RE: DENDROBIUM MINE – WATERNSW RESPONSE TO SUBMISSIONS REPORT

RESPONSE TO WATERNSW COMMENTS

**RE: Dendrobium Mine – Plan for the Future: Coal for Steelmaking
Influence of longwall void width on the predicted subsidence effects**

**RE: Dendrobium – Plan for the Future: Coal for Steelmaking
 Dams Safety NSW Submission**

Figure 1: Stream Mapping (Source: MSEC, 2019b)

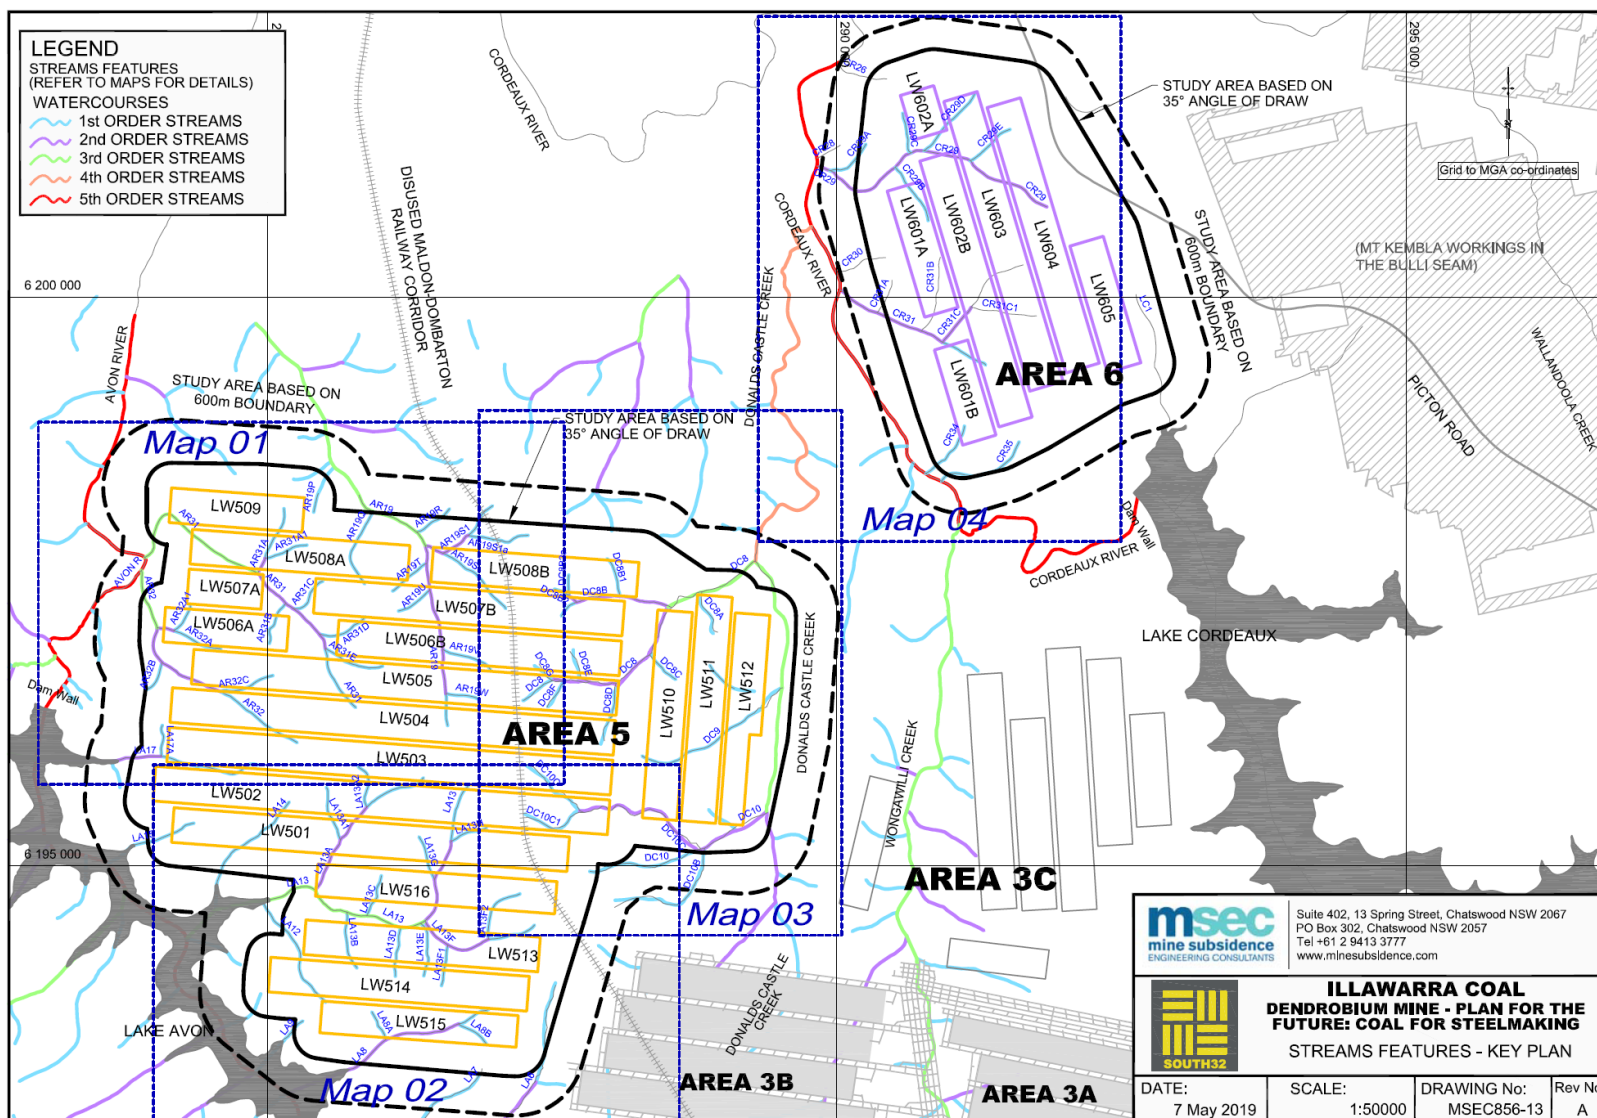
In addition, it appears that with minor adjustments to the mine layout, it is possible to avoid mining directly under second and third order watercourses, for example:

- shifting the western end of LW509 by approximately 150 m to the east,*
- shifting the western end of LW516 by approximately 100 m to the east, and*
- shifting the northern end of LW510 by approximately 400 m to the south.*

It is not feasible for the Project to avoid directly undermining second and third order streams with minor adjustments to the mine plan (Figure 1).

The three examples provided by WaterNSW would themselves result in sterilisation of 0.73 Mt of ROM coal with an equivalent value of approximately \$104M and \$6.5M in associated royalties. These three changes would not result in the Project avoiding the direct undermining of all second and third order streams.

Figure 1 Maximum predicted vertical subsidence versus longwall void width

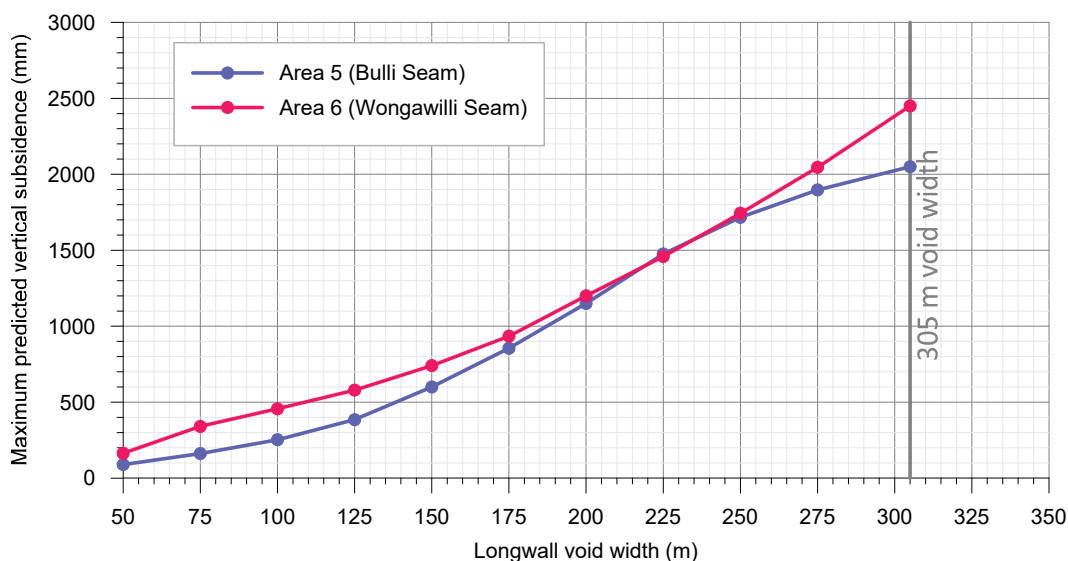
WaterNSW notes that the RTS makes an unsubstantiated statement that adverse environmental impacts are still anticipated for reduced longwall widths down to approximately 150 metres. No reports or data are provided to support this claim.

South32 should be required to provide detailed information on the environmental risk profile from increasing incremental widths of longwalls (e.g. 100 metres, 150 metres, 200 metres and 250 metres).

The relationships between longwall void width and maximum predicted vertical subsidence are illustrated in Figure 1. The predicted vertical subsidence has been obtained using the Incremental Profile Method (IPM) which is described in Sections 3.5 and 3.6 of Report No. MSEC856.

The shapes of the curves for Area 5 and Area 6, shown in Figure 1, differ due to the mining geometry. The proposed longwalls in Area 5 are at shallower depths of cover (i.e. 360 m average) compared with the depths of cover in Area 6 (i.e. 440 m average), whereas the proposed mining heights in Area 5 are lesser (i.e. 2.5 m to 3.2 m in the Bulli Seam) compared with the proposed mining heights in Area 6 (i.e. 3.9 m in the Wongawilli Seam).

The maximum predicted vertical subsidence decreases as longwall void width reduces. The maximum predicted vertical subsidence, as percentages of the maximum predicted value for the 305 m wide longwalls, are approximately 70 % to 80 % for 250 m longwalls, 50 % to 60 % for 200 m wide longwalls and 30 % for 150 m longwalls.
